Front Edge of Engine Under Cover Warped

Market USA

YEAR(S)	MODEL(S)	ADDITIONAL INFORMATION
2010	Prius

Figure 1.

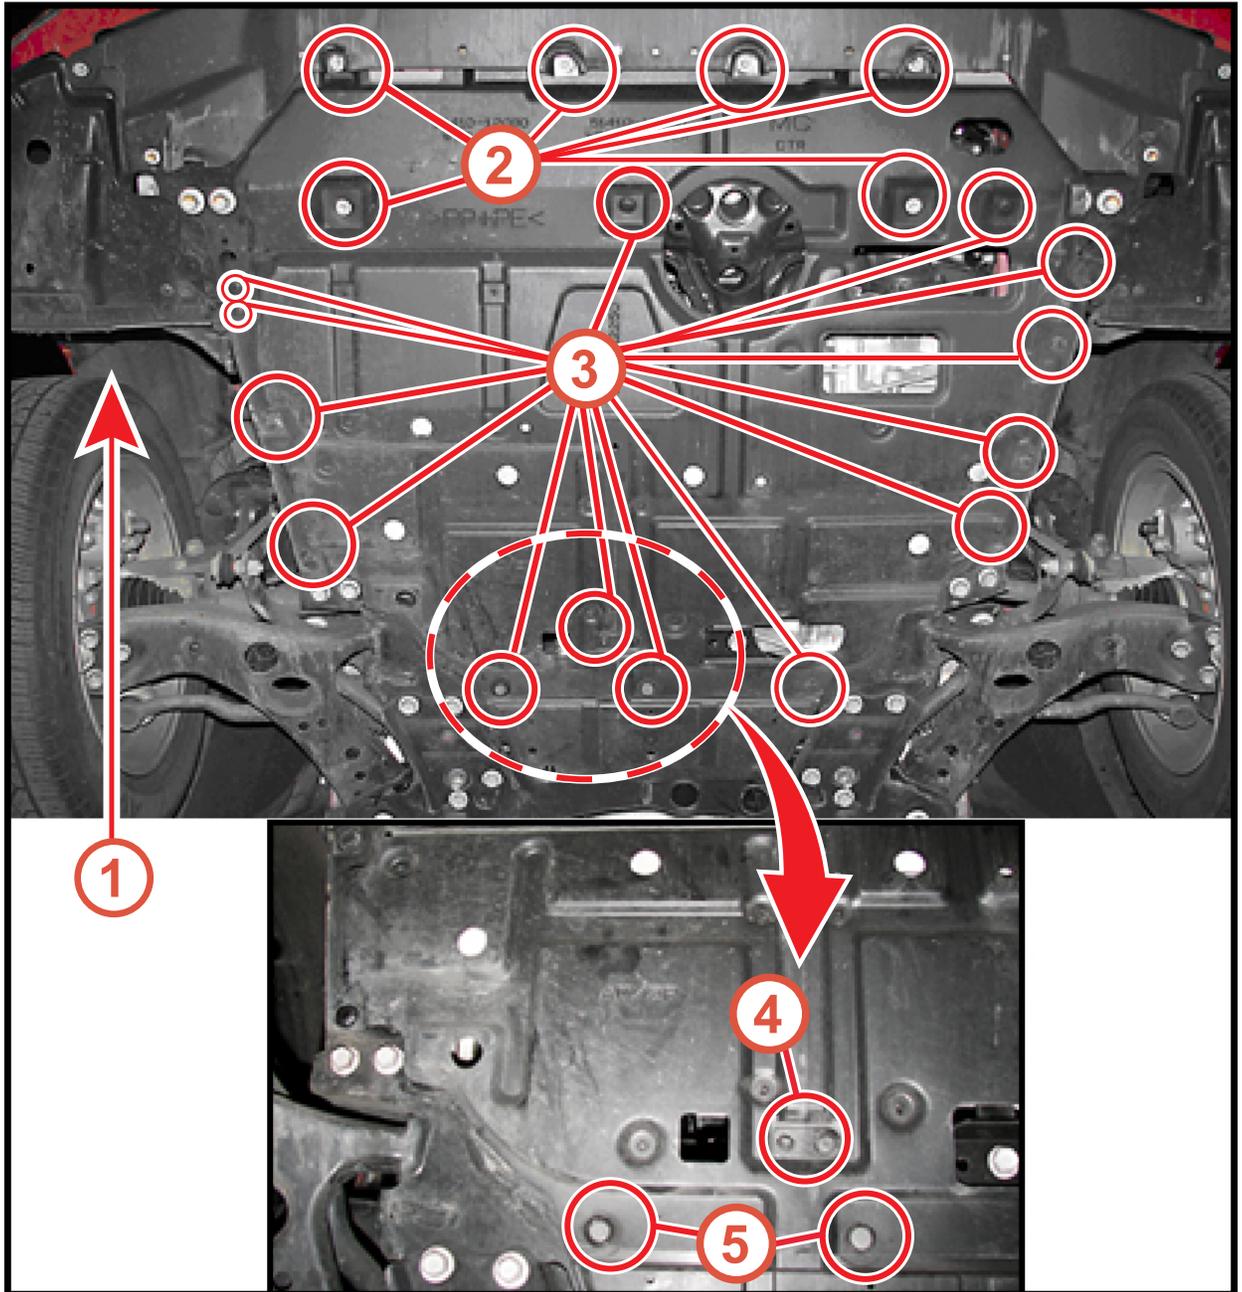
Clips are not interchangeable. See Figure 1 for specific clip locations.

3. Position new engine under cover into place and install the 14 retaining clips in their correct locations, then install the 6 bolts (See Figure 1).

Gently pull down on the edges of the engine under cover to ensure the clips are installed in the correct locations.
